UNITED STATES  
DEPARTMENT OF THE INTERIOR  
BUREAU OF LAND MANAGEMENTFORM APPROVED  
OMB NO. 1004-0135  
Expires: July 31, 2010**SUNDRY NOTICES AND REPORTS ON WELLS**  
*Do not use this form for proposals to drill or to re-enter an abandoned well. Use form 3160-3 (APD) for such proposals.*5. Lease Serial No.  
NMNM54183

7. If Unit or CA/Agreement, Name and/or No.  
89101957708. Well Name and No.  
S LOCO HILLS 139. API Well No.  
30-015-03518-00-S110. Field and Pool, or Exploratory  
LOCO HILLS11. County or Parish, and State  
EDDY COUNTY, NM**SUBMIT IN TRIPLICATE - Other instructions on reverse side.**

OXY USA Inc. - Proposed  
South Loco Hills Unit #13  
API No. 30-015-03518

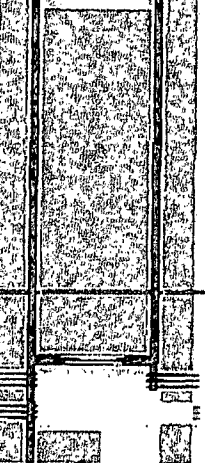
At end of verify cmt to surface 7" annulus.
